Responses to Layer 0 Questions and Comments November 4, 2003

Figure 1. a) Noise measured as a function of analog cable to ground separation. The separation specified for layer 0 is 500 μm . b) Noise as a function of the number of 4'' wires used to ground the layer 0 hybrid demonstrating the effects of wire inductance.

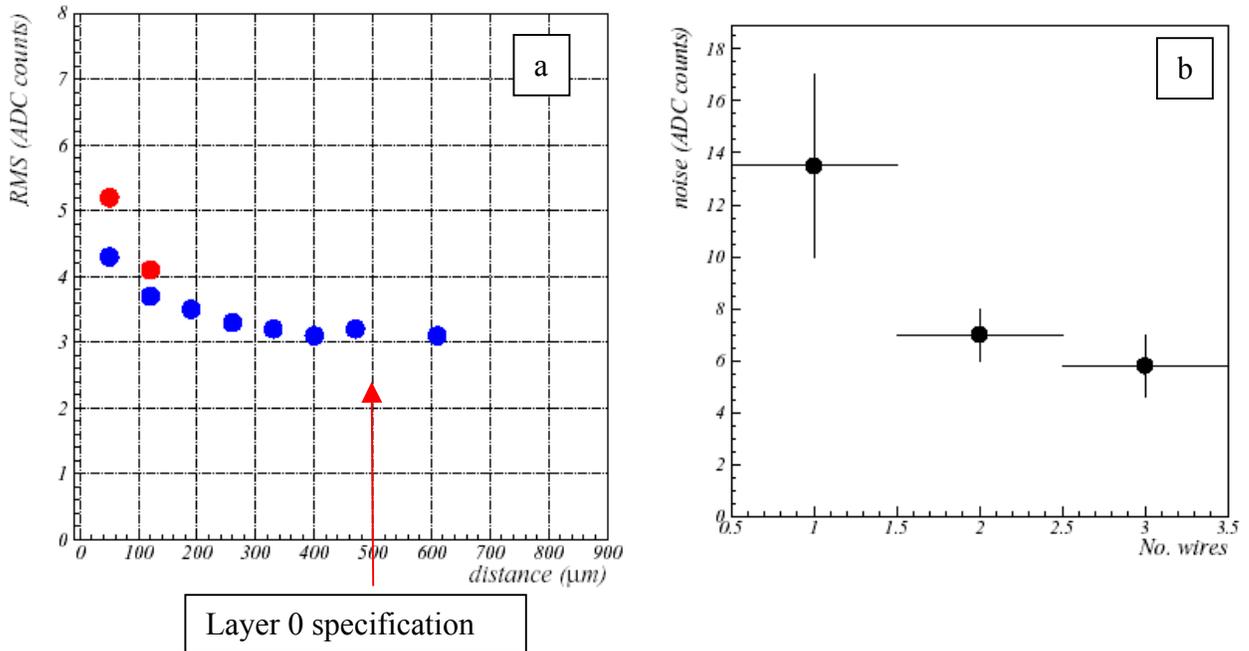
- *The spacing between elements of detector and readout cables controls capacitances and hence cross-talk and hence noise in the readout. The specification of the spacings depends on experience gained by CDF and D0 in the assembly and (difficult) operation of the Run Iia detectors.*

By now it is well known that there have been noise issues in Run Iia with both CDF and D0 detectors. Are the clearances in the Layer 0 design sufficiently conservative?? Again, the pre-installation testing may well be a most important element.

There has been extensive study of these issues for Run2b in D0. We have a comprehensive grounding plan that includes co-curing a kapton mesh grounding circuit in the carbon fiber support layup. We have studied noise and capacitance as a function of clearance and, in all cases, have specified clearance values well in excess of thresholds of observed effects (figure 1). A recent report on this work is available in the last section of an RD03 conference report:

We considered a single point grounding scheme but are concerned that the complex nature of the system and small distances will make parasitic AC grounds and associated ground loops impossible to avoid. Instead we make low inductance connections from the cocured carbon fiber/kapton to both the sensor and hybrid grounds. This provides a solid reference ground for both the sensors and SVX4 chips.
